UNITED STATES PATENT AND TRADEMARK OFFICE

APPLICATION NO.	FILING DATE	FIRST NAMED INVENTOR	ATTORNEY DOCKET NO.	CONFIRMATION NO.
10/623,670	07/21/2003	Oscar Stefanutti	67,022-006	5073

Office Action Summary

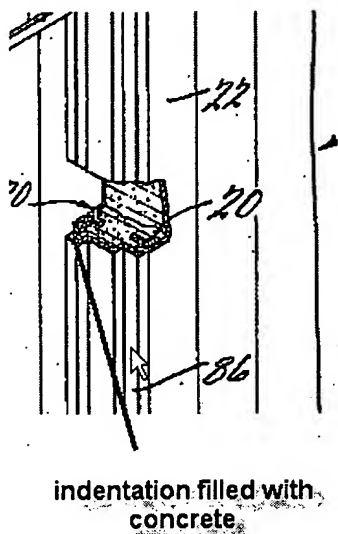
Applicant's argument that Denny does not disclose a window opening comprising a concrete indentation is not found persuasive. This is shown in figure 2 as shown below. This also shows the concrete contacting a portion of a window frame (claim 43).
